Village of Winnetka

Plan Commission Regular Meeting

February 26, 2025 at 7:00 PM
Winnetka Village Hall Council Chambers
510 Green Bay Road

- b. **Case No. 24-08-SU: 225 Sheridan Road - Centennial Park & Beach:** An application seeking approval of (i) a Special Use Permit to allow construction of improvements to the existing park and beach; and (ii) steep slope exceptions to allow walkways, retaining walls, steps, and seating areas within the steep slope zone. The Village Council has final jurisdiction on this request. *This item was continued from the January 22, 2025, Plan Commission meeting. On February 21, 2025, the Winnetka Park District submitted a request that the Plan Commission continue the public hearing to a future Commission meeting. At its February 26, 2025, meeting, the Plan Commission only intends to continue the item to its April 23, 2025, meeting and will not be accepting public comment*

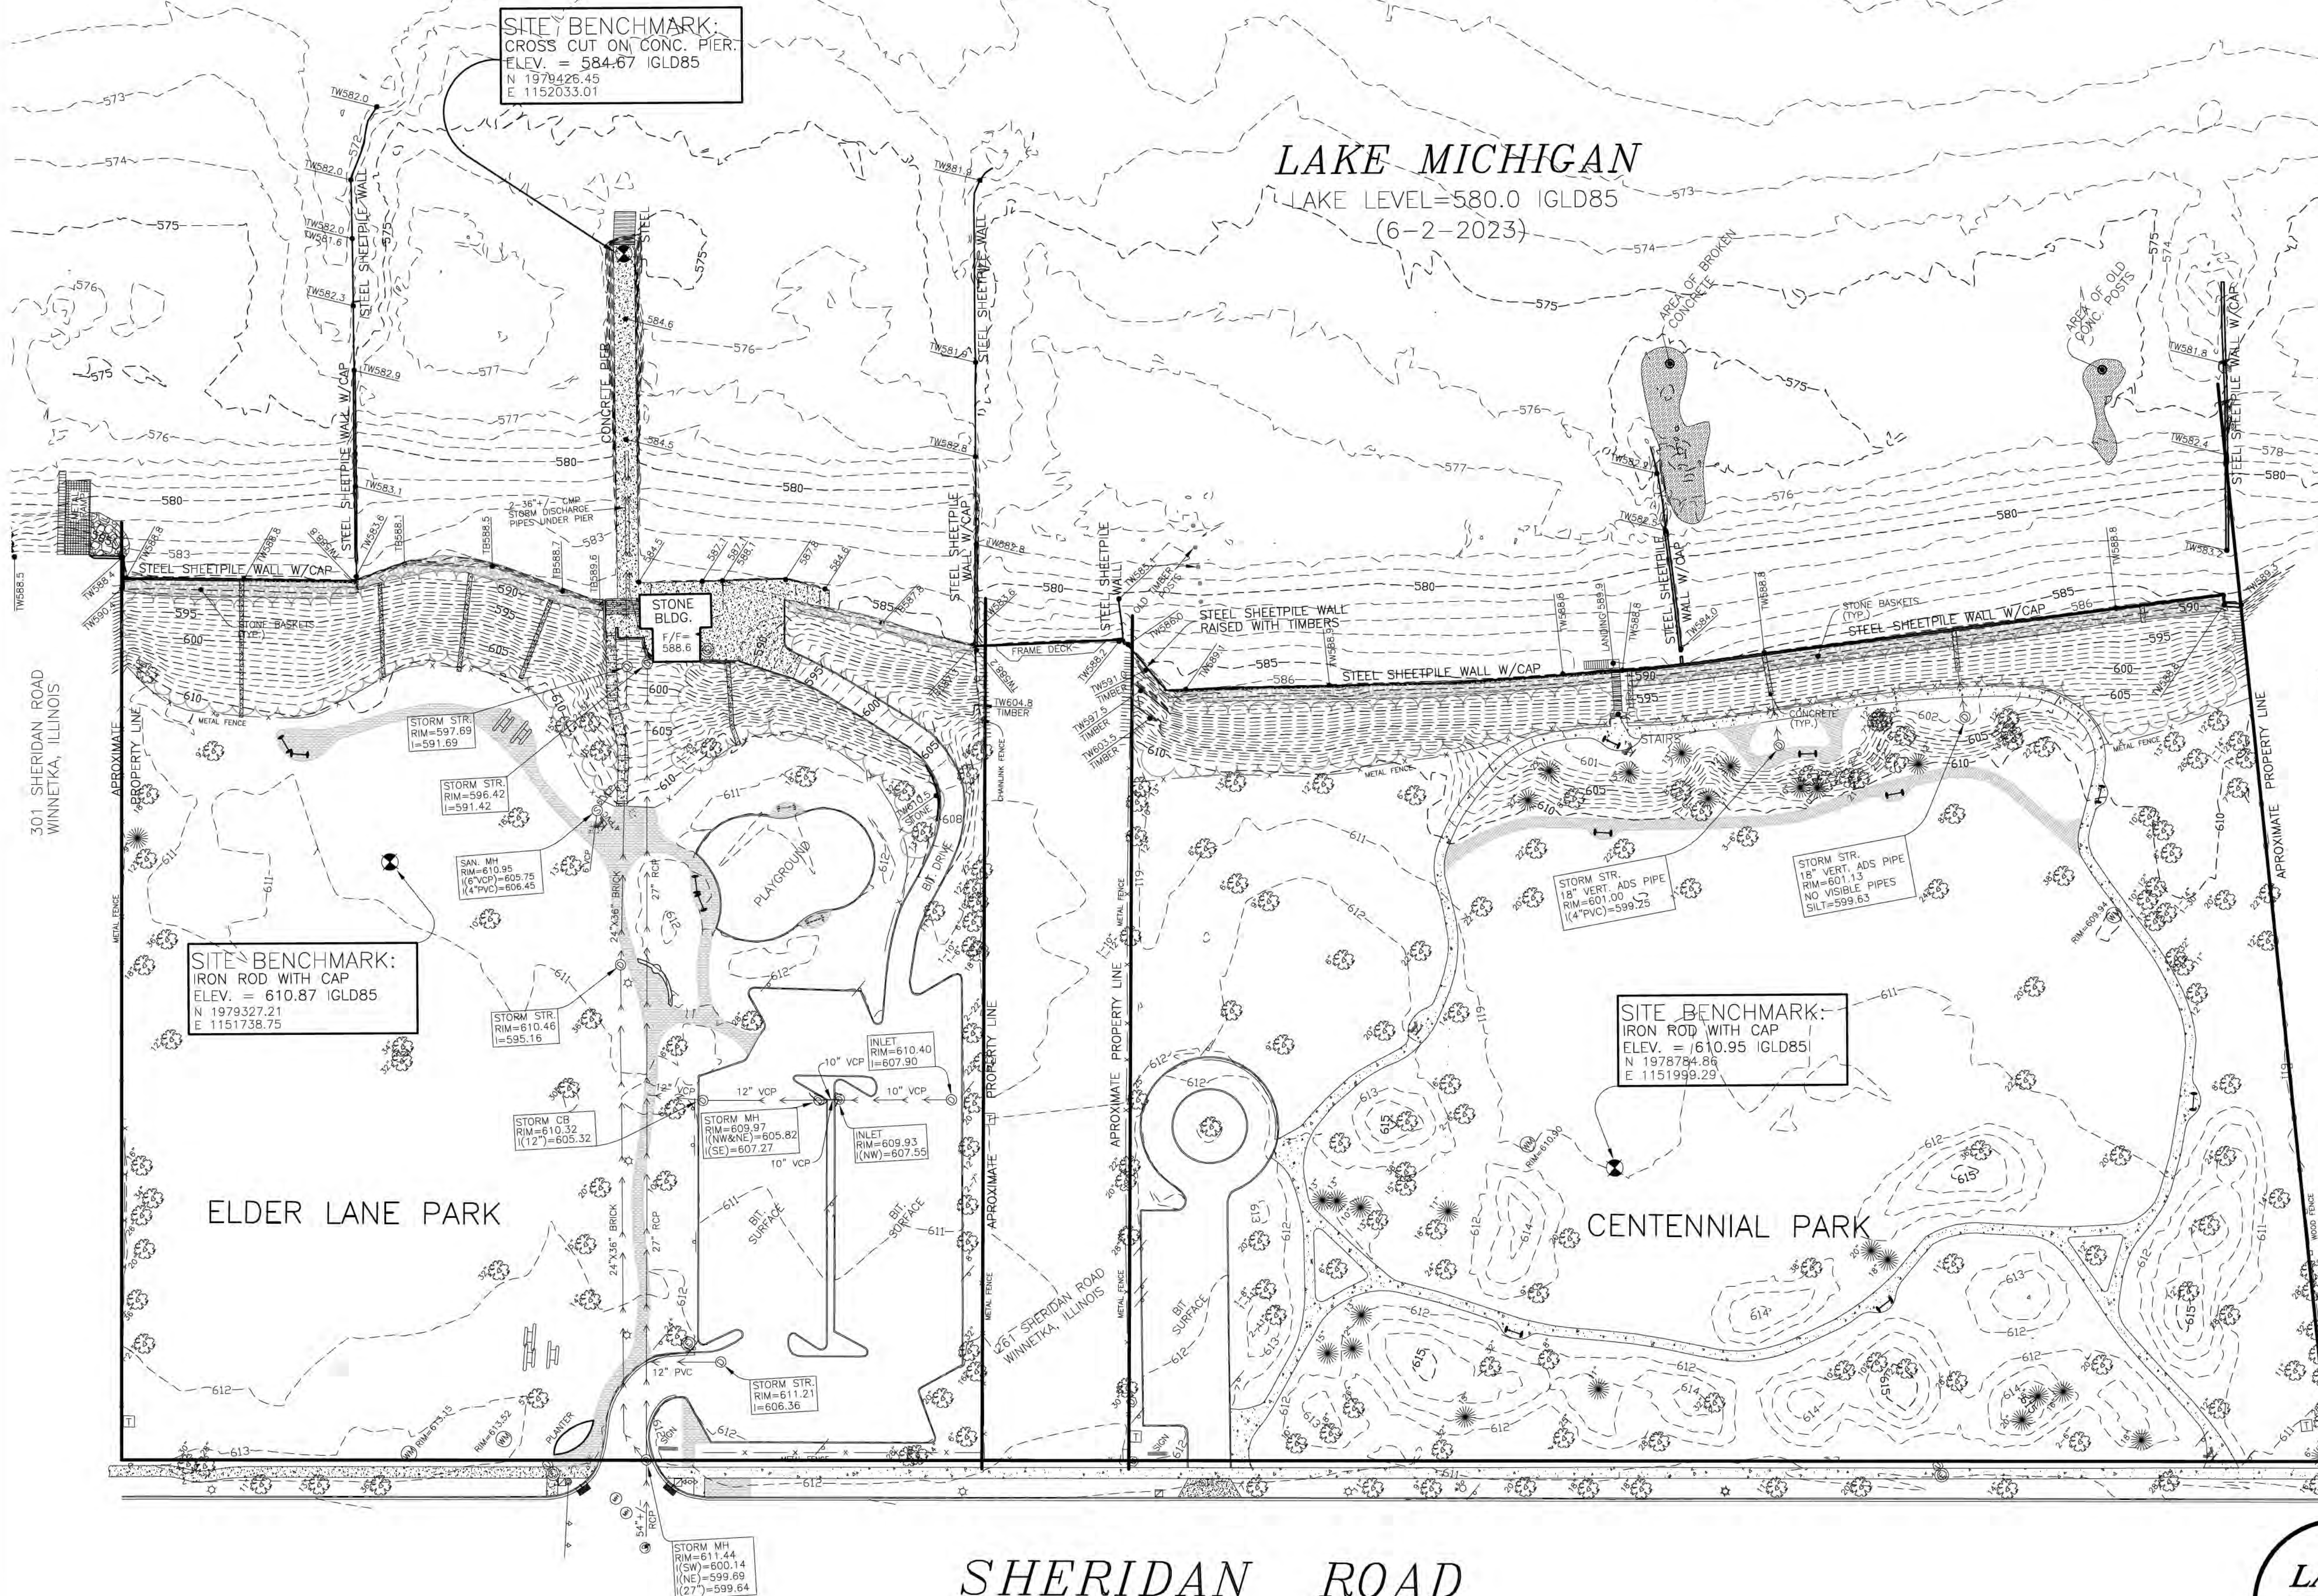
Question: Understand how you are able to build the fencing on the steel groin beyond the extended property line as it extends into the water, and how the access tapers to the stairs and access to the south.

Response: It belongs to the Park District pursuant to Section 11-2 of the Park District Code:
